| JRPP No: | 2012SYE028 |
| Proposed Development: | Bulky Goods Development - Alterations and Additions to the Existing Caringbah Homemaker Centre, Additional Carparking and Landscaping |
| Report By: | Michael Hornery - Environmental Assessment Officer Sutherland Shire Council |

Assessment Report and Recommendation

Figure 5: Proposed reconfiguration of the driveway and the landscape layout plan for the Willarong Road frontage

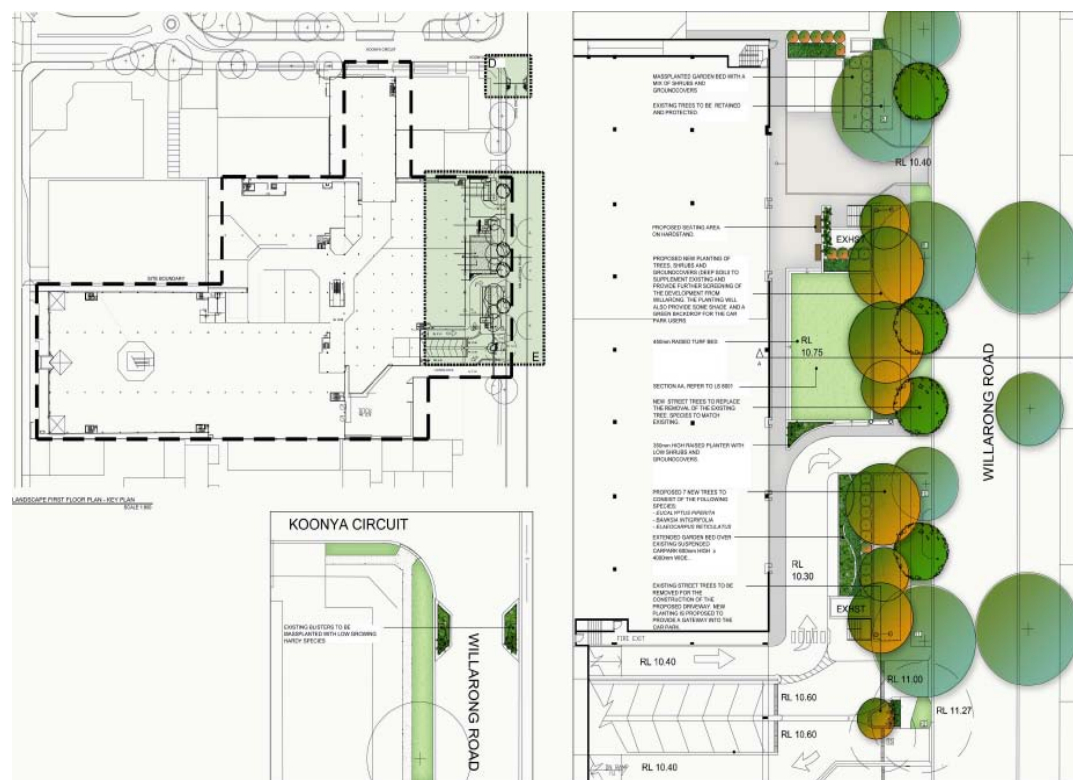
As a result of recommendations of the ARAP, the applicant has increased the amount and location of landscaping within the area between the road and the building. This has resulted in the removal of 14 parking spaces to accommodate approximately 200m² of additional landscaping.

At the request of Council, the applicant has also reduced the length of the exit driveway, resulting in approximately 100m² of landscaped area. This area now provides a grassed area that may be suitable for the purposes of an outdoor staff area. These amendments, in conjunction with previous revisions, now provide a more appropriate interface with the residential properties.
